## Request For Information 19070902-0565

Subject: Sanitary Sewer and Water Line Elevation ConflictDate:07/20/2022Project: LSR7 2020 Bond - Lees Summit High SchoolJob:19070902Address: 400 SE Blue PkwyRequired:07/25/2022

C560

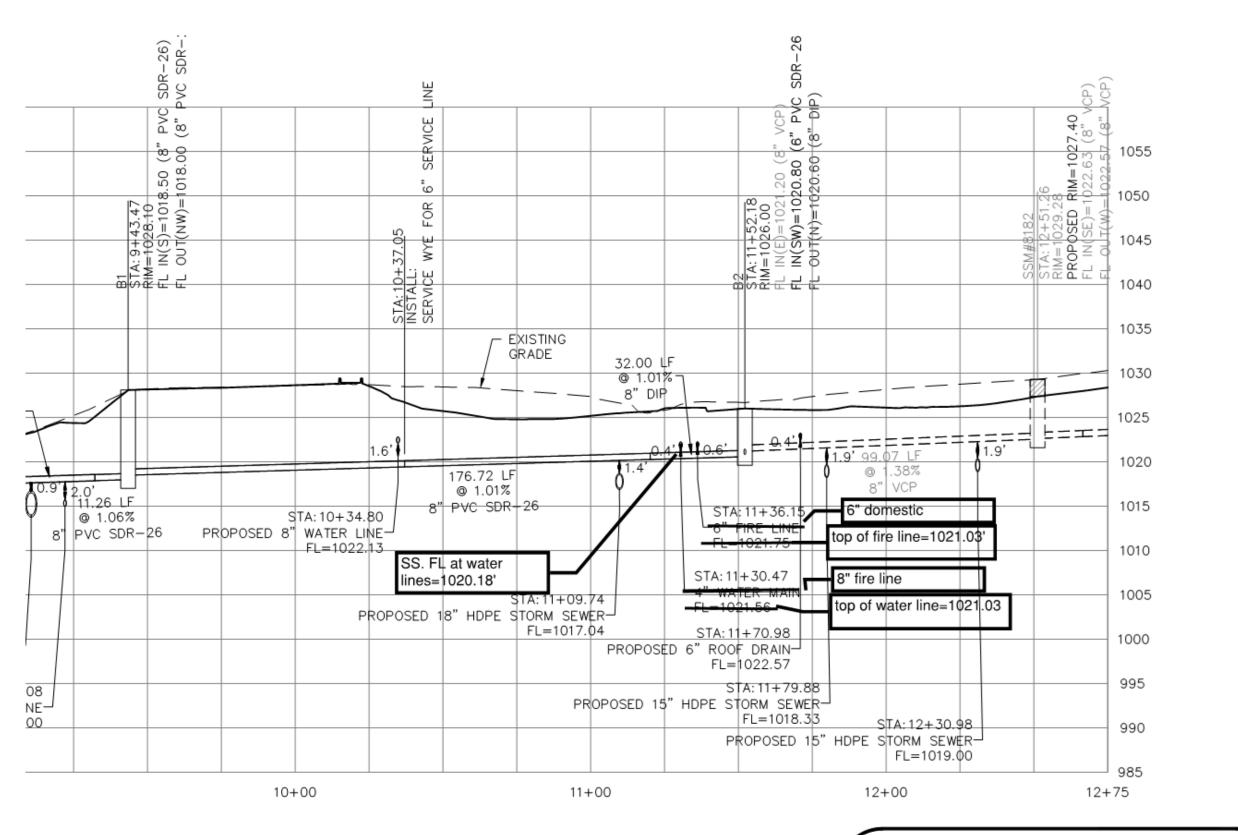
Co-Author: J.E. Dunn Construction Compt Contact: Jared Amold Co-Author RFI Number:						
Reference:						
Spec Section:		Drawings: C	560			
Spec Section:		Drawings:				
Spec Section:		Drawings:				
Request At the downst	tream of Manhole B2, the sewer lir	ne is conflicting with the water line. Plea	se see the attached and advise how to proceed			
Suggestion						
Answer A	Accept Suggestion					
		ve and reinstall proposed don				
	service line in accordance with Sheet C520 to avoid conflict with the proposed sanitary line.					
	It was brought to KVE'	s attention that the existing 8	" VCP Public			
	Sanitary Line at Manhole B2 is higher than plan elevation. The pipe					
	•	ast shall be modified in accor				
	•	mmodate field elevations. App	•			
	Sheet C560 (Revision	to modifying Structure B2. Re 9)	ererence Plan			
Answered By:	David Wood	Signed:
